UNITED STATES  
NUCLEAR REGULATORY COMMISSION  
WASHINGTON, D. C. 20555  
April 11, 1991

SUBJECT: ISSUANCE OF AMENDMENT (TAC NO. 79374)

AMENDMENT TO PROVISIONAL OPERATING LICENSE

SAFETY EVALUATION BY THE OFFICE OF NUCLEAR REACTOR REGULATION

FIGURE 3.3.1  
OYSTER CREEK P/T LIMITS

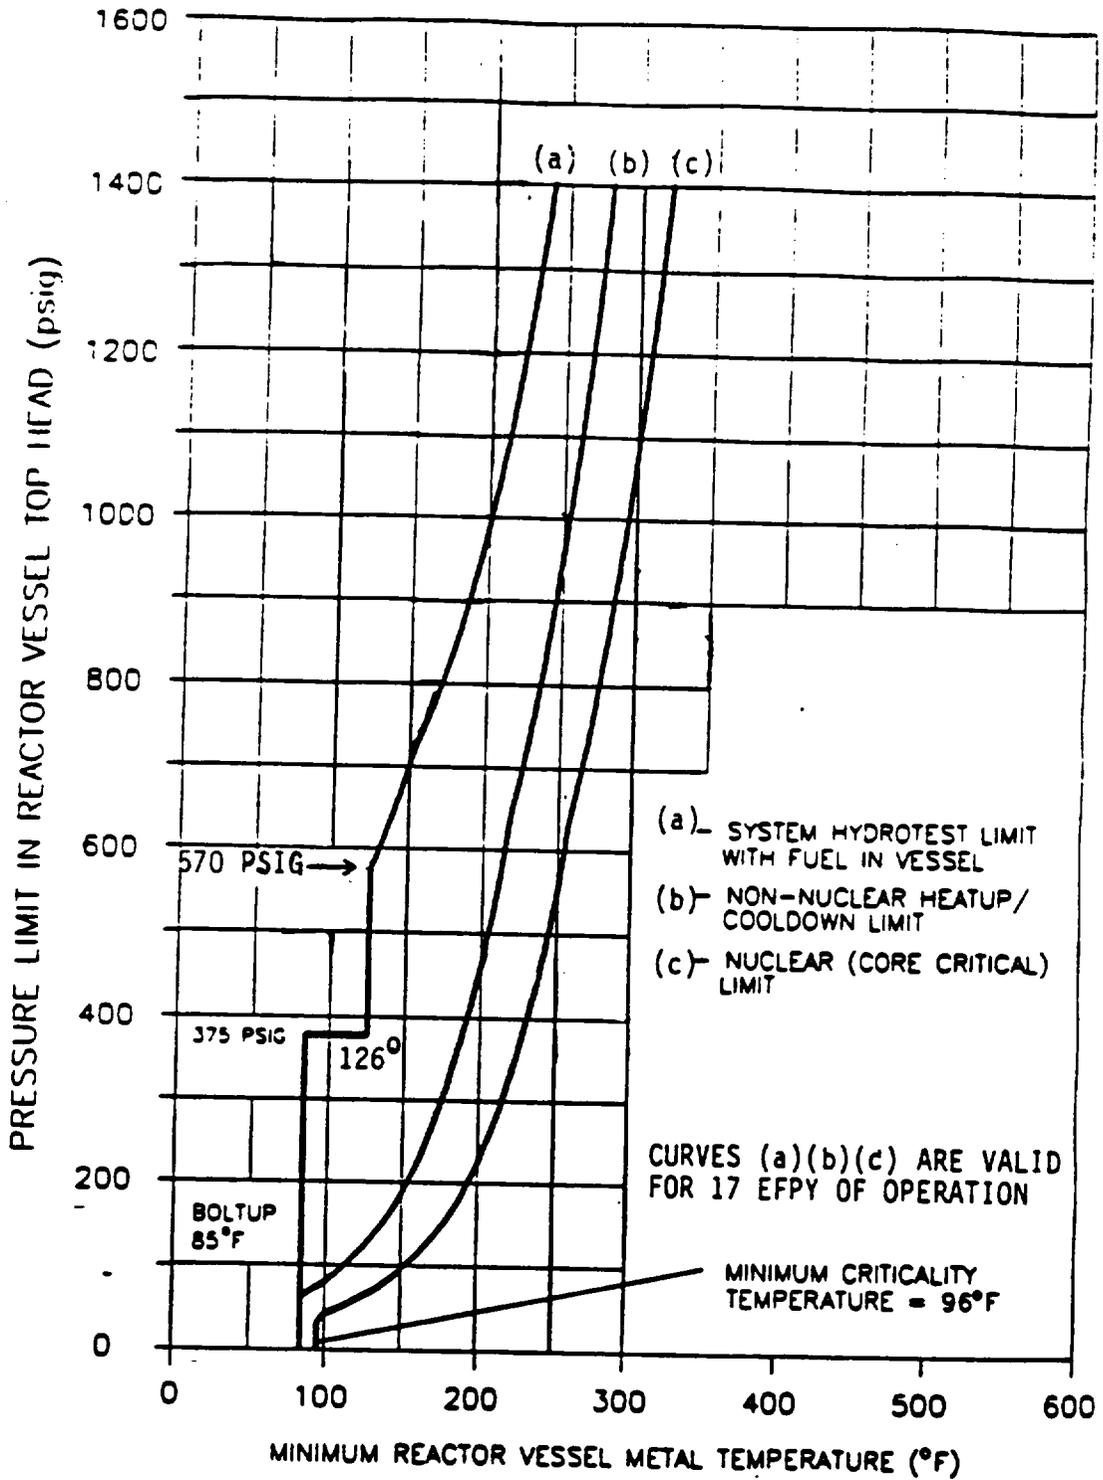
The staff evaluated the effect of neutron irradiation embrittlement on each beltline material in the Oyster Creek reactor vessel. The amount of irradiation embrittlement was calculated in accordance with RG 1.99, Rev. 2. The staff determined that the material with the highest ART at 17 EFY was the intermediate shell course plate G-8-6 with 0.20% copper (Cu), 0.51% nickel (Ni), and an initial  $RT_{ndt}$  of 31°F.

For the limiting beltline material, plate G-8-6, the staff calculated the ART to be 137.4°F at 1/4T (T = reactor vessel beltline thickness) and 116.1°F for 3/4T at 17 EFY. The staff used a neutron fluence of 1.25E18 n/cm<sup>2</sup> at 1/4T and 5.5E17 n/cm<sup>2</sup> at 3/4T. The ART was determined using Section 1 of RG 1.99, Rev. 2, because only one surveillance capsule has been removed from the reactor vessel.

The licensee used the method in RG 1.99, Rev. 2, to calculate an ART of 137.5°F at 1/4T for the same limiting plate metal. Substituting the ART of 137.5°F into equations in SRP 5.3.2, the staff verified that the proposed P/T limits for hydrotest and cooldown meet the SRP 5.3.2; however, the licensee's heatup limits at 1000 psi is about 19°F less conservative than the staff's calculation.

In the normal BWR operation, the reactor coolant system (RCS) is heated based on the thermodynamic saturated steam line which is much more conservative than the P/T limits. Based on this consideration, the staff believes that the 19°F difference is acceptable; therefore, the proposed P/T limits for heatup is also acceptable.

In addition to beltline materials, Appendix G of 10 CFR Part 50 also imposes P/T limits based on the reference temperature for the reactor vessel closure flange materials. Section IV.2 of Appendix G states that when the pressure exceeds 20% of the preservice system hydrostatic test pressure, the temperature of the closure flange regions highly stressed by the bolt preload must exceed the reference temperature of the material in those regions by at least 120°F for normal operation and by 90°F for hydrostatic pressure tests and leak tests. Paragraph IV.A.3 of Appendix G states "an exception may be made for boiling water reactor vessels when water level is within the normal range for power operation and the pressure is less than 20 percent of the pre-service system hydrostatic test pressure. In this case the minimum permissible temperature is 60°F (33°C) above the reference temperature of the closure flange regions that are highly stressed by the bolt preload." Based on the flange reference temperature of 25°F, the staff has determined that the proposed P/T limits satisfy Section IV.2 of Appendix G.

The staff concludes that the proposed P/T limits for the reactor coolant system for heatup, cooldown, leak test, and criticality are valid through 17 EFPY because the limits conform to the requirements of Appendices G and H of 10 CFR Part 50. The proposed limits also satisfies Generic Letter 88-11 because the licensee used the method in RG 1.99, Rev. 2 to calculate the ART. Hence, the proposed P/T limits may be incorporated into the Oyster Creek Technical Specifications.
